Subdivision Authority

File No. LDA10-0173

RE: Tentative plan of subdivision to create 100 single detached residential lots and 26 semi-detached residential lots from a portion of Lot 2, Plan 782 2211 and a portion of Lot 51, Block RW, Plan 752 0669, located north of 4 Avenue SW and west of 50 Street SW;  
**CHARLESWORTH**

## SUBDIVISION CONDITIONS OF APPROVAL MAP

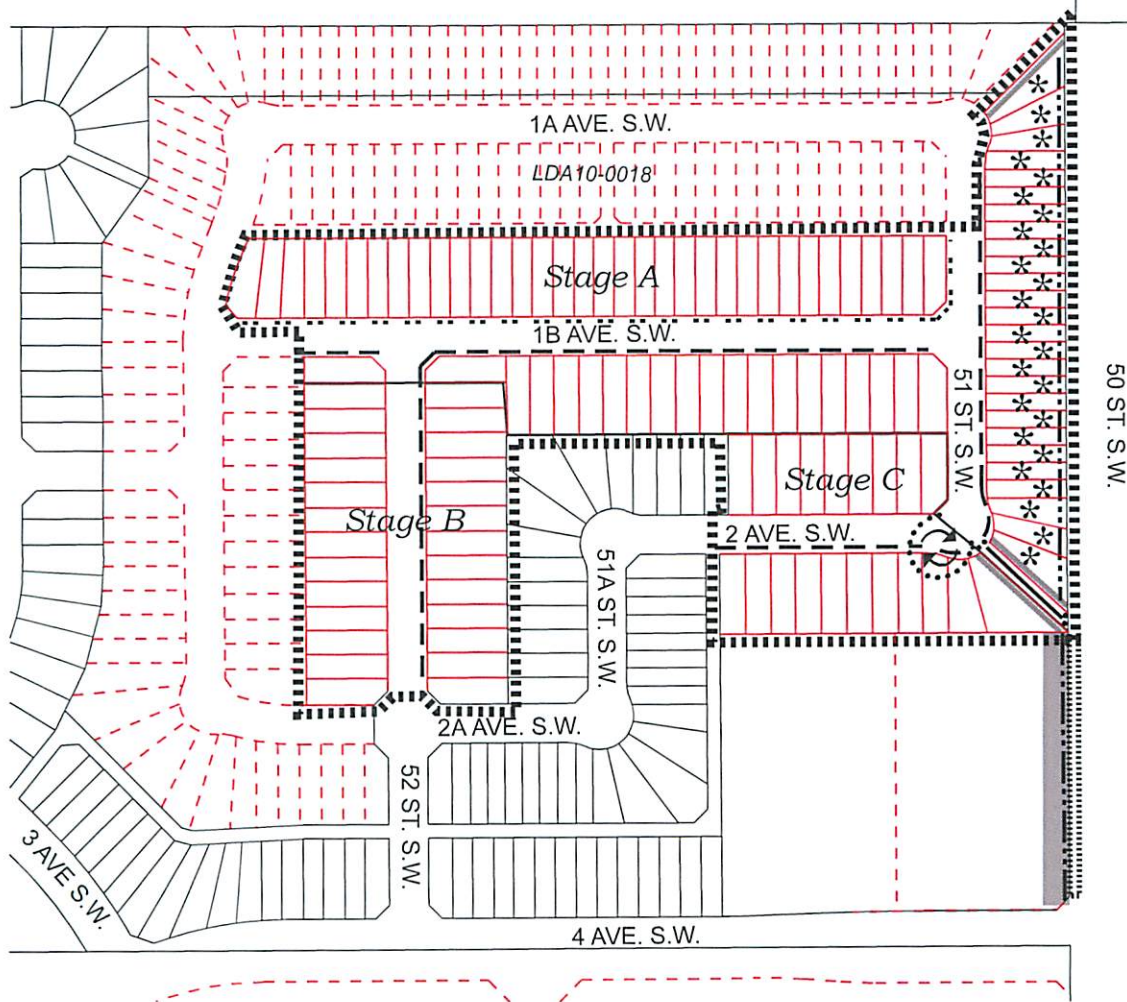
4. that the owner be permitted to register this plan of subdivision in stages, as shown on the "Conditions of Approval" map, Enclosure I, at the discretion of the Chief Subdivision Officer, having regard to the provision of roadways and the logical extension of services;

5. that the approved subdivision within the Charlesworth Neighbourhood (File LDA10-0018) be registered prior to or concurrent with this application;
6. that the subdivision boundary be amended to include the dedication of 50 Street SW to conform to an approved concept plan or to the satisfaction of the Transportation Department, as shown on the "Conditions of Approval" map, Enclosure I;

7. that the owner clear and level 50 Street SW to the satisfaction of the Transportation Department;
8. that the owner prepare a restrictive covenant in favour of the City of Edmonton that will be registered against the proposed lots backing on to 50 Street SW as shown on the "Conditions of Approval" map, Enclosure I, to protect the integrity of the berm; and

7. that the owner provide no parking signage on local roads to the satisfaction of the Transportation Department;
8. that the engineering drawings include a 1 m berm and 1.8 m double board/no gap solid uniform screen fence as shown on the "Conditions of Approval" map, Enclosure I;

9. that the owner construct a 12 m gravel temporary turnaround with bollards with Stage A to the satisfaction of the Transportation Department in the location as shown on the "Conditions of Approval" map, Enclosure I;

11. that the owner construct all fences, sidewalks, lighting and bollards to the satisfaction of the Transportation and Asset Management and Public Works Department in the locations as shown on the "Conditions of Approval" map, Enclosure I.
